WHT Corrector System FDR - MRR

Agenda - 30th November 2017

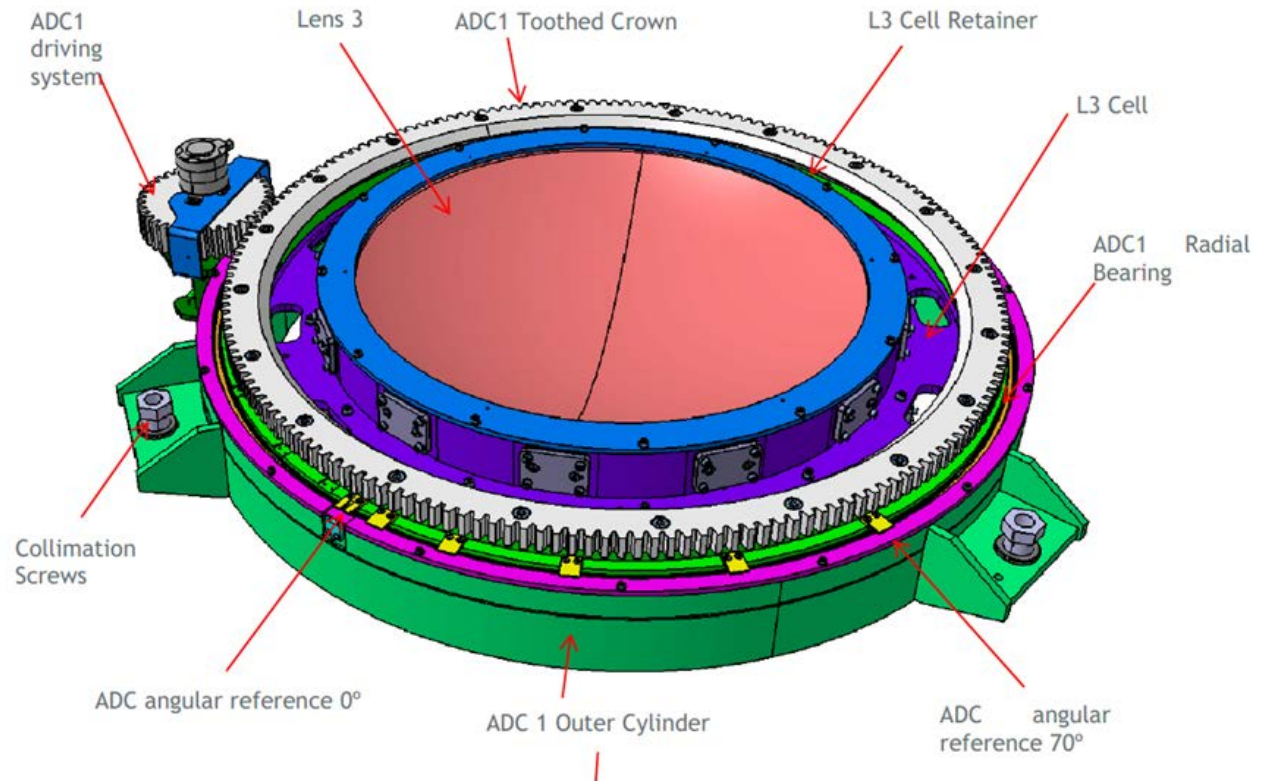
Key	Summary	Description	Comments	
			Author	Text
WEAVEWCSFDR-32	Gear centring requirements?	Pg129 step 63: Does the gear need centring to ensure consistent tooth engagement?	Francesc Dalmasas	This has been previously determined using shimming for the pinion Open
			Paul Jolley	Shimming the pinion sets the tooth engagement at one position of the crown gear. If the crown gear is eccentric then the tooth engagement will keep changing. The question is whether changing tooth engagement affects the performance and if so by how much?

The effect of eccentricity is negligible. Requirement is $0,1^\circ$:

- Crown eccentricity estimated $0,2\text{mm}$ + radial runout bearing $0,02\text{mm}$.
Total $0,22\text{mm} \Rightarrow 0,028^\circ$
- Pinion eccentricity estimated $0,1\text{mm}$ + radial runout bearing $0,05\text{mm}$.
Total $0,15\text{mm} \Rightarrow 0,03\text{mm}$ on the crown due to gear ratio $\Rightarrow 0,003^\circ$
- Pinion pitch error $0,043\text{mm} \Rightarrow 0,005^\circ$ in the crown
- Crown pitch error (estimated): $0,2\text{mm} \Rightarrow 0,026^\circ$
- Total error (RSS) = $0,038^\circ$

On top of that the rotation accuracy will be calibrated

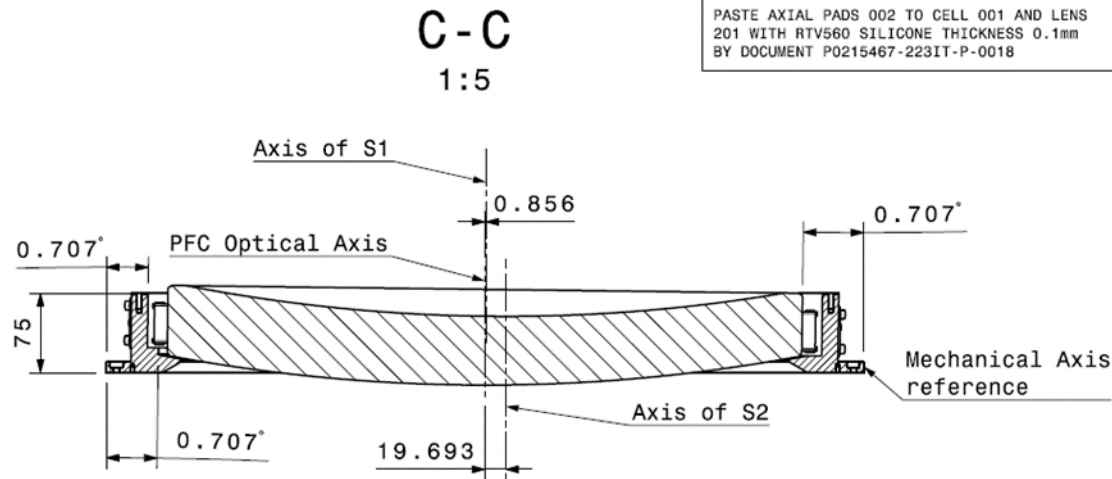
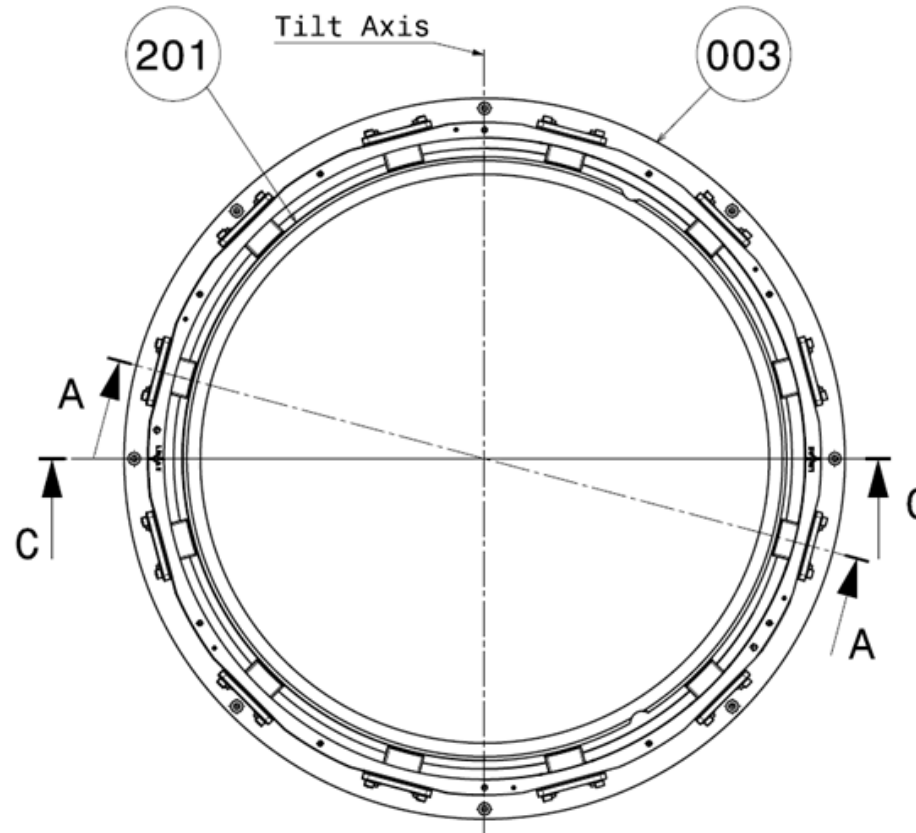
Key	Summary	Due Date	Description	Author	Comments
WEAVEWCSFDR-35	L4 tilt centre		Pg145 step 86: It is difficult to see where the centre of rotation (tilt) of L4 is from the manufacturing drawing. Can you please provide a sketch so I can check this?	Francesc Dalmasas	I think the best is the information included in the L4 manufacturing drawing, which is generated by ING
				Paul Jolley	attached Open The drawing you refer to details where the center of rotation should be. What I'd like to see is a sketch of the lens in the cell with an indication of where the center actually is in the final design. Is the lens tilted about the correct surface/point while maintaining its axial alignment? This is just to double check that everything is OK.

The drawing is updated. Clocking tolerance L4 to L4 Cell to be defined:

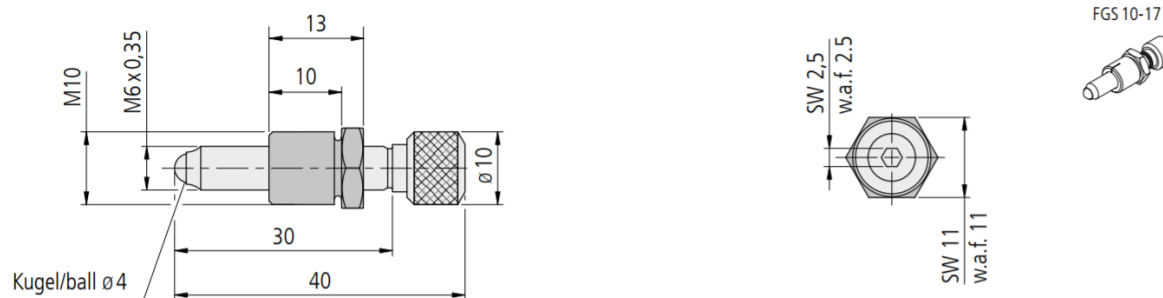
Key	Summary	Description	Comments	
			Author	Text
WEAVEWCSFDR-41	Adjustment resolution/accuracy	Pg81: Can you please provide details on all the adjustment screw resolutions and how they compare to the alignment requirements.	Francesc Dalmasas	pitch is 0,5mm so 15° is 20 micron. Open Can you provide a table stating all the adjustments (both translations and tilts) and how this resolution compares to the required alignment tolerances/resolution?
			Paul Jolley

XY adjustment for ADC1, ADC2 and L6 vs L1 is OWIS FGS 10-17. 0,35mm pitch. 10° rotation is 10 micron < 45 /50 micron

17 mm Stellweg, Einschraubgewinde M10	17 mm travel, mounting thread M10	Typ/type	Bestell-Nr./part no.
		FGS 10-17	91.163.1017

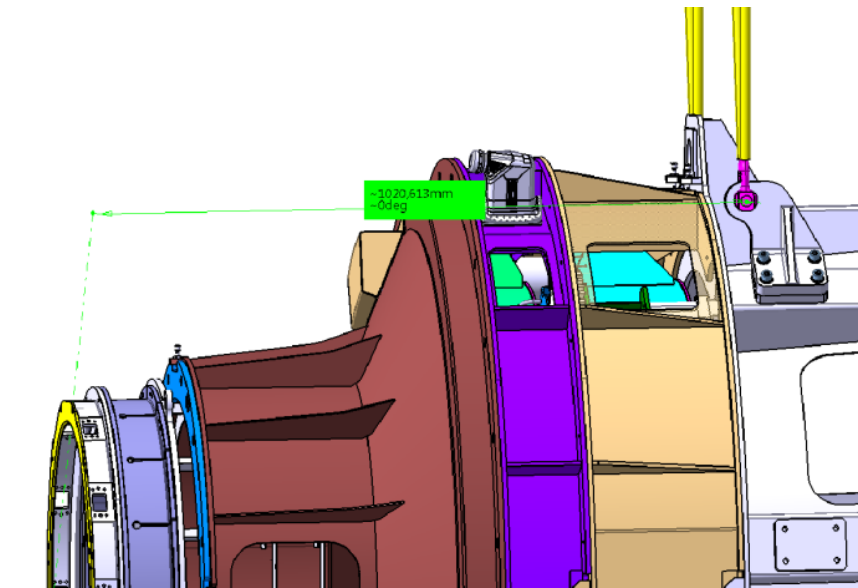
Key	Summary	Due Date	Description	Comments	
WEAVEWCSFDR-45	Safer lifting of WCS		Pg125: Lifting the WCS horizontal using just 2 points as shown does not seem to be a good idea. There is a danger of the WCS rotating. Can you use a third point to prevent this?	Author	Text
				Francesc Dalmases	the lifting is at the center of gravity, no risk of flipping open The center of the lifting points are 58mm from the CoG (1080-1022). This would result in a $1700 \times 9.81 \times 0.058 = 967\text{Nm}$ out of balance torque IF the estimate of the CoG is correct. In fact, the requirement is for the CoG to be at 1017 from L6S2 which makes the out of balance torque even worse. Please show how you intend to lift in more detail. How will you adjust the lifting points to balance the WCS sufficiently to move it safely? Could you tell me when and how often a horizontal lift is carried out? Maybe there's no issue.....

LINEAR GUIDE XY

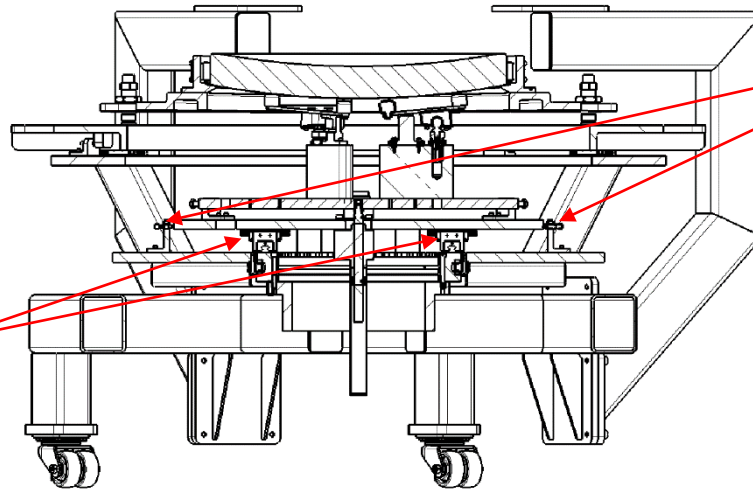
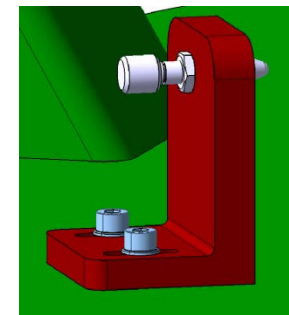
Key	Summary	Due Date	Description	Comments	
WEAVEWCSFDR-51	Cell support on alignment table		<p>How is the XY baseplate (for the cell) supported on the alignment table - I can't tell from the figures.</p> <p>The cells are bolted to the cell tilt adjust plate - what is the expected distortion of the tilt plate as it support at three points (coupled with distortion of XY plate below). This is an issue as it will feed back to the axial support heights as the cell is clamped to the support.</p>	Author	Text
				Francesc Dalmasas	<p>We can include more detail in the procedure</p> <p>I would like to see this at the meeting.</p>
Peter Doel

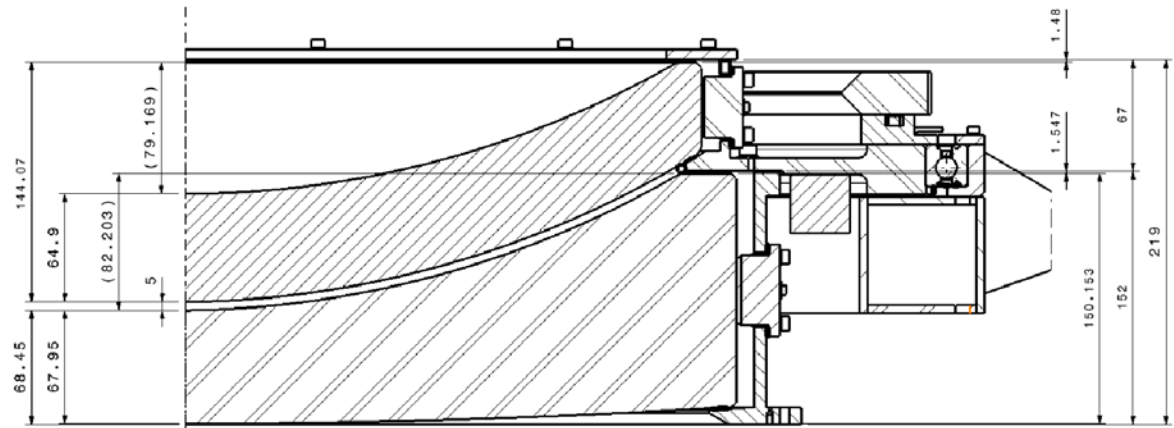
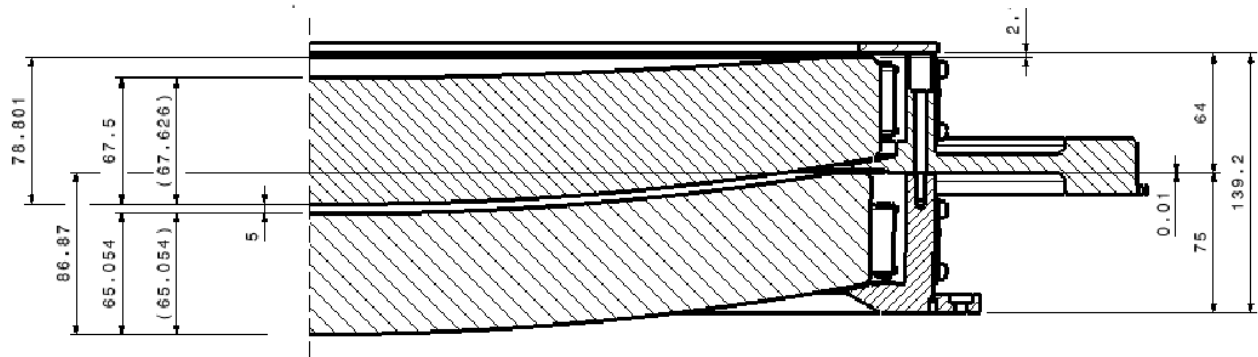
Key	Summary	Due Date	Description	Comments	
WEAVEWCSFDR-53	Separation of Lenses in ADCs		Can you clarify how the correct spacing of L2 to L3 and L4 to L5 in the ADCs is confirmed/measured and adjusted?	Author	Text
				Francesc Dalmasas	This is to be done by measuring the lenses
				Peter Doel	More detail is needed on this procedure

ADC1: measuring distances between L2 and L3 to their cells in axial we can estimate the spacing between L2 and L3 according their manufacturing as built info. Additional machining or shimming would be required but this can be previously estimated using the dummies.

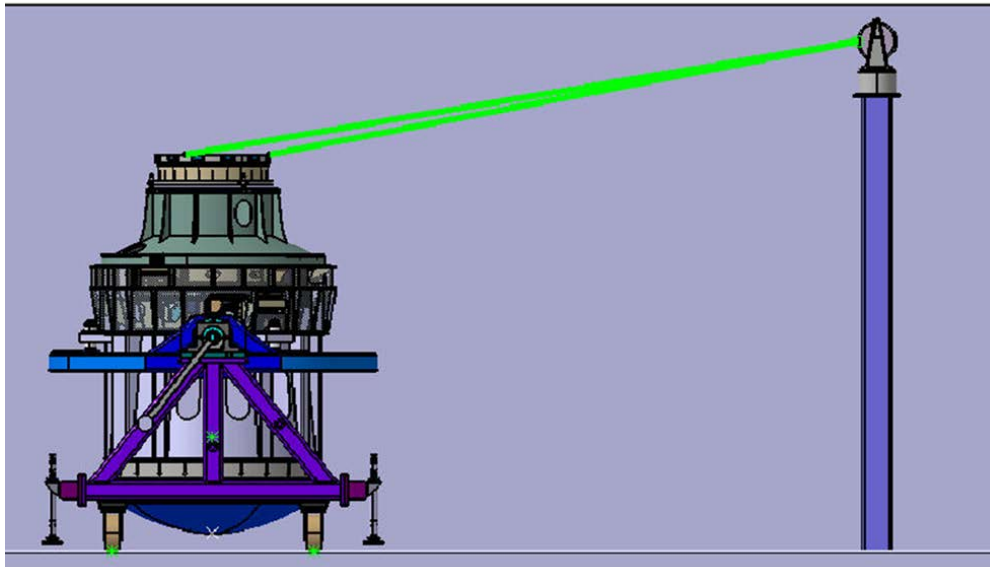
Key	Summary	Due Date	Description	Comments	
WEAVEWCSFDR-54	Laser tracker		The laser tracker is a key part of the alignment but there seems to be little information on its set up and operation - is more detail available? (perhaps I've missed it!)	Author	Text
				Francesc Dalmases	this is to be done by a external measument company I would like to explore this at the meeting - it is a key part of the alignment
				Peter Doel

Laser tracker visibility inside the clean room is checked for the worst case (L6).

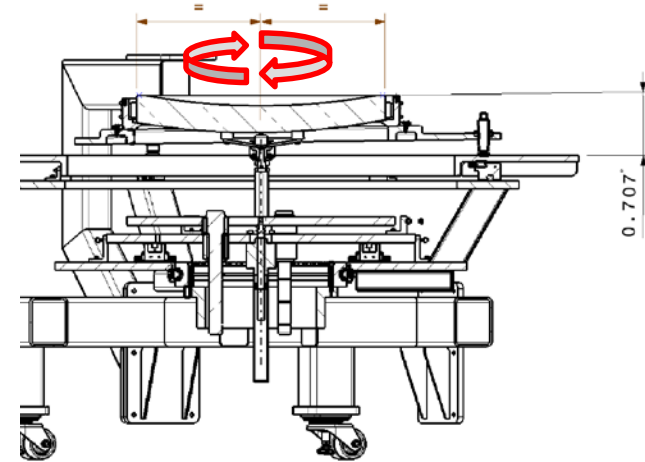
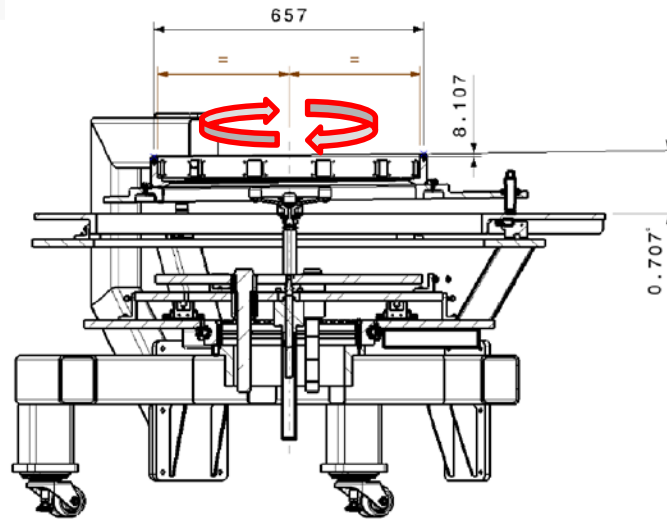
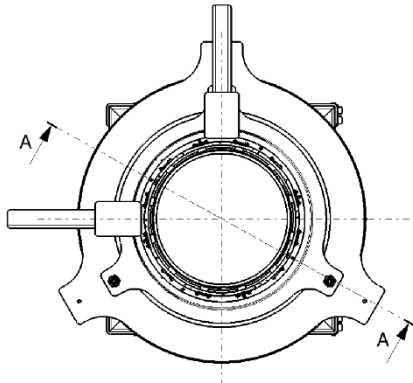
Key	Summary	Due Date	Description	Author	Comments
WEAVEWCSFDR-55	Statement on page 151		<p>I don't understand the following statement on page 151 can you clarify</p> <p>"IMPORTANT: L4 is tilted 0.707° wrt optical axis, so the L4 cell axial support is tilted by 0.07° (rest is lens manufacturing). The centring of L4 cell will be done tilting it wrt rotary table to aling the L4 cell axial support surface to the the rotation axis".</p>	Francesc Dalmases	<p>We can include clarifications. We have proposed to tilt the rotation table support to be able to measure. I would like this clarified</p>

M12x18 (x3) USED FOR LIFTING

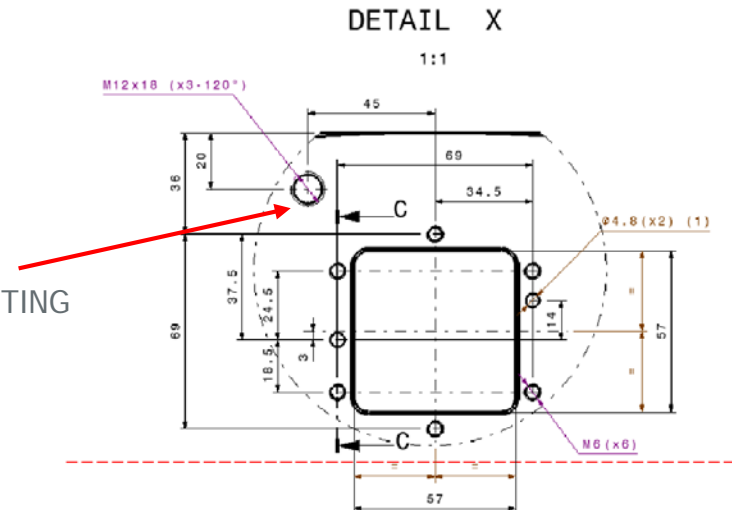
Key	Summary	Due Date	Description	Comments	
WEAVEWCSFDR-7	Missing holes		Pg28 step 4: There are no M6 lifting holes in the manufacturing drawing of the flexure ring (they are in the CAD model).	Author	Text
				Francesc Dalmasas	Agreed. Typo in procedure. Should be M8. Procedure will be corrected
				Paul Jolley	Open You have 3 M6 holes in the CAD model specifically for this lift. Are you now changing the CAD model to M8? The manufacturing drawing does not have any holes in it, M6 or M8. You need to add the hole details to the drawing and make it consistent with the procedure.

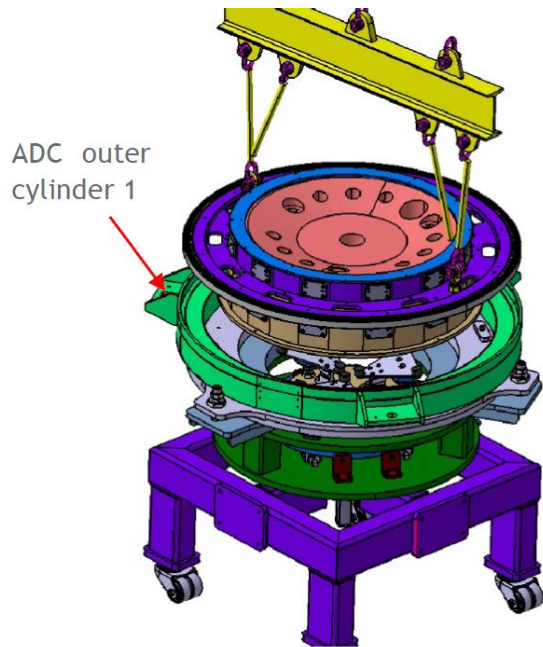
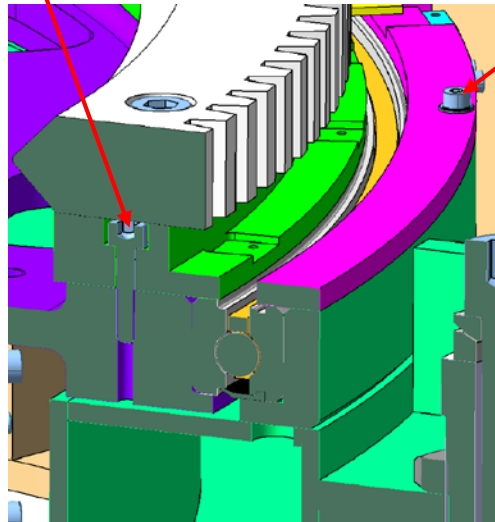
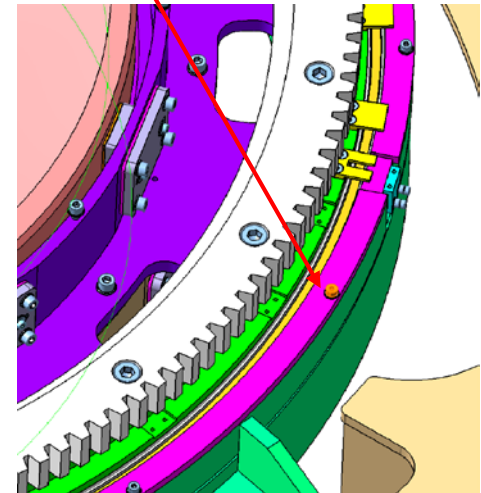
Key	Summary	Due Date	Description	Comments	
<u>WEAVEWCSFDR-17</u>	Clarification on bearing assembly		Pg42 step 20: I don't understand what is meant by the 4th paragraph. The CAD model shows the bearing press-fitted into the outer cylinder. There is a bearing retainer bolted to the L3 cell, but this is held with M6x25 bolts. Paul Jolley	Author	Text
				Francesc Dalmases	We will check in detail. Retainer is fixed by M4 bolts. We will check consistency of drawings. Open
					A simple slide at the meeting to present the process would be good to see. Not a show stopper for the project.

M6x25

M4x20

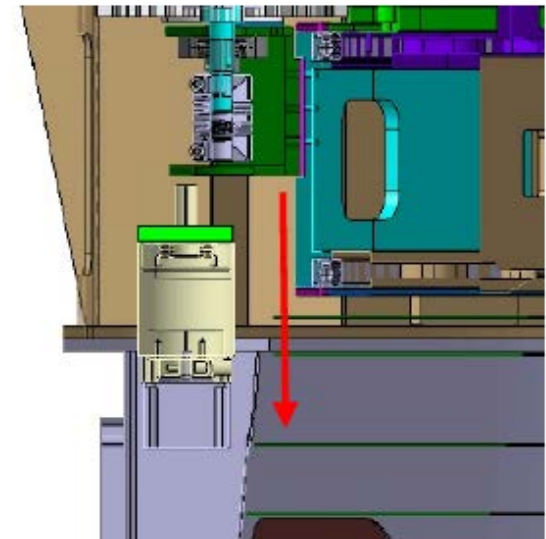
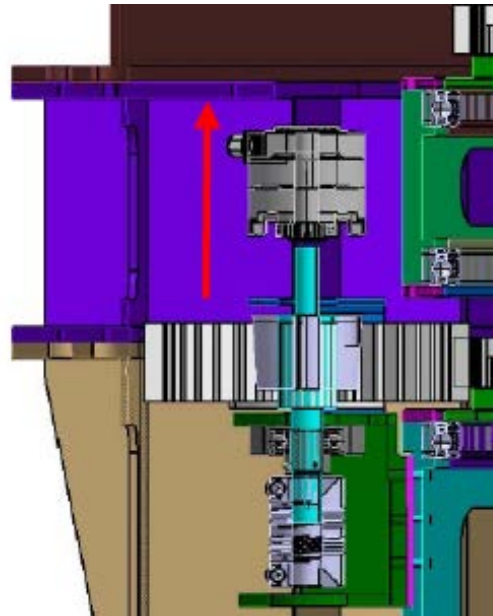
Key	Summary	Description	Comments	
			Author	Text
WEAVEWCSFDR-19	Drive units - LRU's?	Pg43 step 21: Are the drive units pre-assembled and pre-tested?	Francesc Dalmasas	Yes. All are COTS Open
			Paul Jolley	My question was if the drive unit as a whole is an LRU and not if it consists of individual COTS items. Please Clarify. Not a show stopper.

There two assemblies:
one for the Motor and
Gearbox, the second for
the Encoder.
Both can be replaced in
the telescope
